Access Compliance Report

Public Rights-of-Way

Intersection ID: 10036975	Main Street: S_TRYON_ST	Cross Street: N/A	Location: NW
ADA ID: 04A8523F48A8	Ramp Type: Perp	Initial Pass/Fail: Fail	Overall Compliance: No
Severity Score: 46.25			
Codes/Mitigation Info/Possible Solution		Field Measurements/Component Compliance

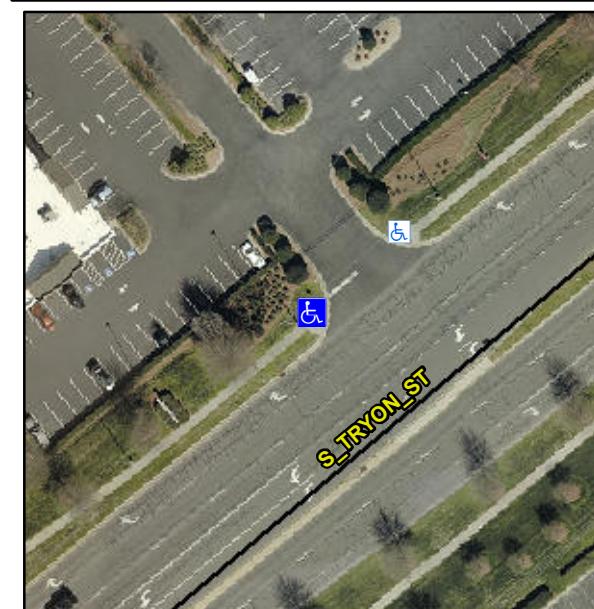
R304.5.1, R304.2.2, R304.5.3

Compliance	Description	Data	Compliance	Description	Data
N/A	Ramp Length (in)	101.0	No	Ramp Slope (%)	8.7
No	Ramp Width (in)	47.0	No	Ramp XSlope (%)	9.1
N/A	Flare Type LT	N/A	N/A	Flare Type RT	N/A
N/A	Flare Slope LT (%)	N/A	N/A	Flare Slope RT (%)	N/A
N/A	Flare Traversable LT?	N/A	N/A	Flare Traversable RT?	N/A
N/A	Landing Length (in)	N/A	N/A	DWS Provided?	N/A
N/A	Landing Width (in)	N/A	N/A	DWS Contrast?	N/A
N/A	Landing Slope (%)	N/A	N/A	DWS Length (in)	N/A
N/A	Landing X Slope (%)	N/A	N/A	DWS Full Width?	N/A
N/A	Landing Curb? (Y/N)	N/A	N/A	DWS Offset (in)	N/A
N/A	Shared Landing?	N/A			
N/A	Gutter Ponding?	N/A	N/A	Gutter Slope (%)	N/A
N/A	Gutter Lip Ht (in)	N/A	N/A	Gutter X Slope (%)	N/A
N/A	Painted X Walk1?	No	N/A	Painted X Walk2?	N/A
	X Walk 1 Direction	To E		X Walk 2 Direction	N/A
N/A	X Walk 1 Width (in)	N/A	N/A	X Walk 2 Width (in)	N/A
	X Walk 1 Slope (%)	4.3		X Walk 2 Slope (%)	N/A
	X Walk 1 X Slope (%)	2.0		X Walk 2 X Slope (%)	N/A

Remove & Replace Entire Ramp.
